| Product hierarchy no. * | | | | Part no. | SBU | Type / Description | Customer part no. |
|-------------------------|-----|-----|------------|----------------|---------------------------------|--------------------|-------------------|
| 02 | 005 | 016 | 0000002219 | See list below | Power Entry Modules w/o Filters | 4719 | |

2 Type of change

| Product Change Notification | | | | | PCN 4719 | | |

3 Detailed description of change

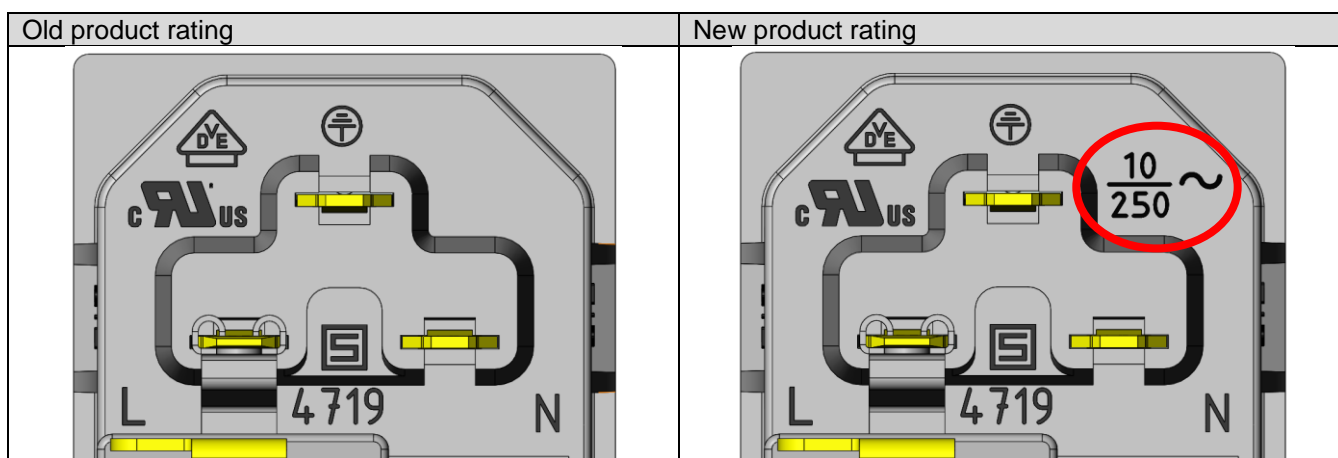
Rating 10A@250VAC for UL and VDE added

| Form | Yes | Markings for the rating of UL and VDE added to moulding body |

Standard-Update to UL/CSA 60320-1
